UNITED STATES PATENT AND TRADEMARK OFFICE

10/535,067

Wolfgang Huber

Office Action Summary	Application No. 10/535,067	Applicant(s) HUBER ET AL.	
	Examiner Alexander B. Comley	Art Unit 4156

FIG. 1

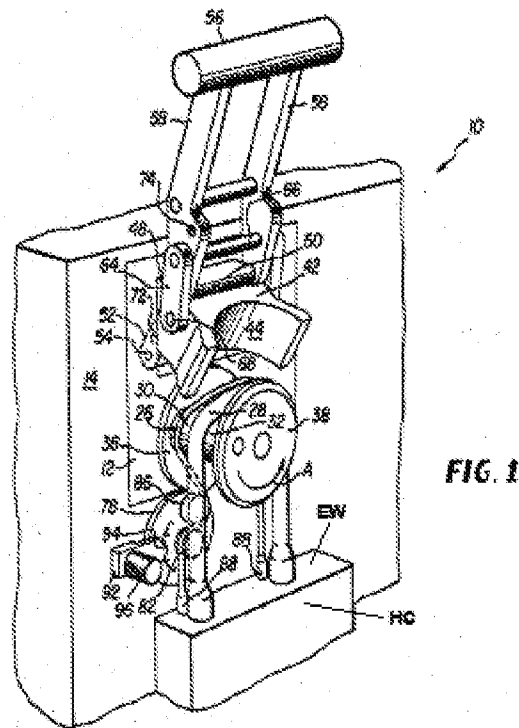
3. In regards to Independent **Claim 7**, and in reference to Figure 1 shown immediately above, Lamadrid (4,256,442) discloses:

A peristaltic pump (10) comprising: a plurality of rotating squeeze rollers (30, 32); a squeeze hose (28) connectably looped around the squeeze rollers (30, 32); a contact wall (44); and a setting lever (56); the contact wall (44) being opposite the squeeze rollers (30, 32), whereby the contact wall (44) is connected to and movable by the setting lever (56), wherein the squeeze hose (28) is compressed by the squeeze rollers (30, 32) by moving the setting lever (56) which engages the contact wall (44) against the squeeze hose (28).

As shown in Figure 1 above, Lamadrid discloses all elements of the claim. In particular, applicant's contact wall is taught by Lamadrid's inner race 44, which serves the same purpose of compressing the pumping tube between it and the opposing squeeze rollers.

4. In regards to dependent **Claims 8 and 12**, and again in reference to Figure 1 above, Lamadrid discloses:

(8) The peristaltic pump according to Claim 7, wherein the squeeze rollers (30, 32) are positioned on a housing base (12), wherein support detents (70) for receiving pivot cams (72, 76) of the setting lever (56) are provided on the housing base (12).

(12) The peristaltic pump according to Claim 7, wherein the squeeze hose (28) is provided on a hose carrier (HC) when the housing is open and is positionable at a housing end wall (EW).

As shown above in Figure 1, Lamadrid discloses rollers positioned on the base of the pump, along with support detents for receiving the pivoting cams of the lever mechanism. In particular, Lamadrid specifically discloses "Detent means are in fact, however, defined between the operating handle and the links, as well as between the pressure plate housing and the pump base. Such detent means serve a two-fold purpose, the first of which is to additionally insure the fact that the pressure plate is retained in either its open or closed position, and the second purpose is to audibly indicate that the pressure plate has in fact attained either its open or closed position." (Column 3, Lines 15-25) Furthermore, a hose carrier HC is shown in Figure 1 of

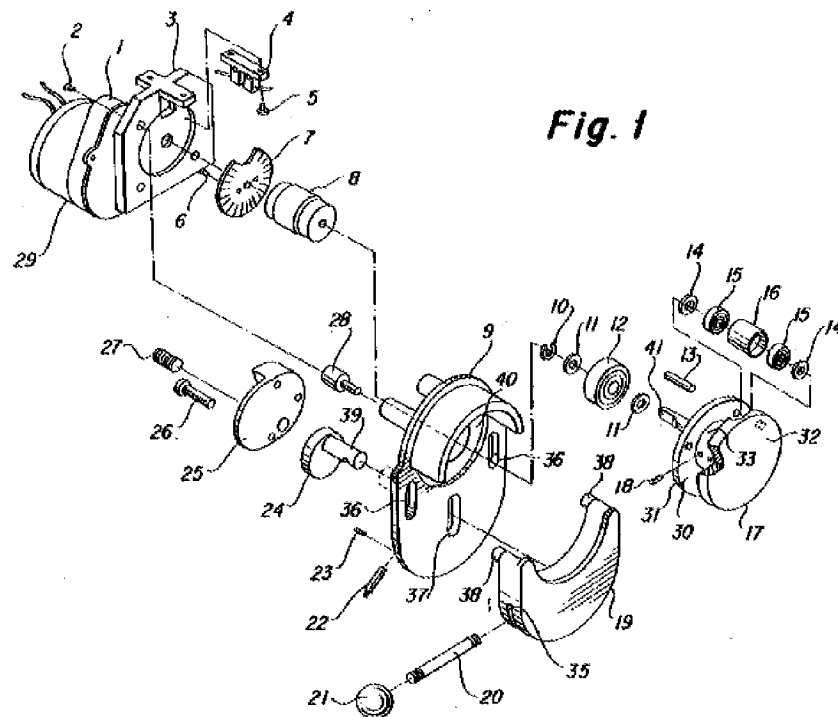
6. Claim 9 is rejected under 35 U.S.C. 103(a) as being unpatentable over Lamadrid in view of United States Patent Leveen (4,813,855) directed to a Peristaltic Pump.

7. In regards to dependent **Claim 9**, and in reference to Figure 1 immediately above, Lamadrid in view of Leveen (4,813,855) discloses:

The peristaltic pump according to Claim 8, wherein the guides (36) for receiving slide rails (38) for a housing cover (19) are provided on the housing base (9).

As shown in Figure 1 immediately above, the Leveen portion of the combination discloses all elements of the claim. Leveen specifically discloses guide slots 36 provided on the housing base 9 for guiding and receiving the cover's projections 38. Furthermore, Leveen specifically discloses a housing cover operation that is the same as applicant's housing cover operation by disclosing, "Pump housing 9 is provided with vertical slots 36 in mounting plate 42 to receive the projections 38 on the shoe 19 which permits vertical movement of the shoe 19 against the face of plate 42 of the pump housing. This vertical movement of the shoe 19 permits opening as shown in FIGS. 2

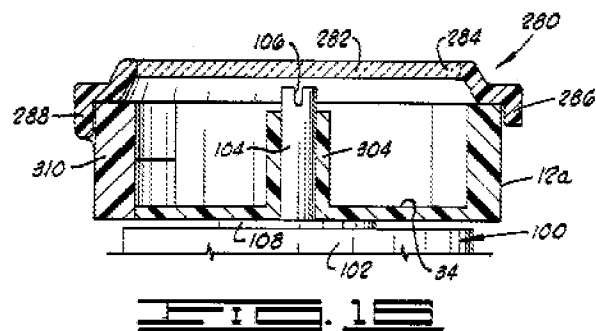
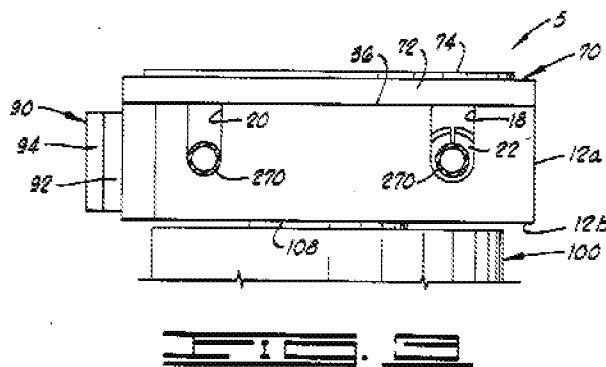
8. Claims 10 & 11 is rejected under 35 U.S.C. 103(a) as being unpatentable over Lamadrid in view of United States Patent Becker (4,588,996) directed to an Easy Load Peristaltic Pump.

8. In regards to dependent **Claims 10 & 11**, and in reference to Figures 3 & 15 immediately above, Lamadrid in view of United States Patent Becker (4,558,996) discloses:

(10) The peristaltic pump, wherein an end wall with a detent tongue (12a) and with two substantially U-shaped recesses (18, 20) for passage of the squeeze hose (270) is provided on the housing base (12b).

(11) The peristaltic pump, wherein the setting lever is constructed as a yoke with a counter detent (286) for detenting on a detent tongue (12a) when the housing (12b) is closed.

As shown in Figures 3 and 15 above, Lamadrid in view of Becker discloses all elements of the claims. In particular, as shown in Figure 3, Becker shows a detent member 12a, along with two U-shaped slots 18 and 20 for accepting and retaining the squeeze hose. In particular, Becker discloses "Fixed stator member 12a is provided with two openings 18 and 20 for the inlet and output ends of the tubing and have orifices equally designed for accepting at either orifice one pump segment fitting/tube grip/stop 22 which secures the resilient collapsible tubing 270 in a permanent position relative to the fixed stator member 12a, i.e., the tube grip 22 prevents any movement of the resilient collapsible tubing 270 in or out of the fixed stator 12a." (Column 8, Lines 60-69) Furthermore, as shown in Figure 15, Becker discloses a counter detent 286 for detenting with the detent member 12a to restrain the pivoting cover from opening. In particular, Becker discloses "In this alternate embodiment, front flap 286 may fit in snapping engagement over the front portion of fixed stator member 12a (not shown). This alternate embodiment is further provided with a remote offset hinge and flap 288 which rotates around common axis hinge pins 290 so that the alternate door assembly 280 may comfortably rotate vertically about the door stator 310 (not shown) once the front flap 286 of lid 280 is unsnapped from the fixed stator member 12a." (Column 13, Lines 13-22) Therefore, it would have been obvious to one of ordinary skill in the art of peristaltic pumps to modify the pressure plate movement system of Lamadrid with the
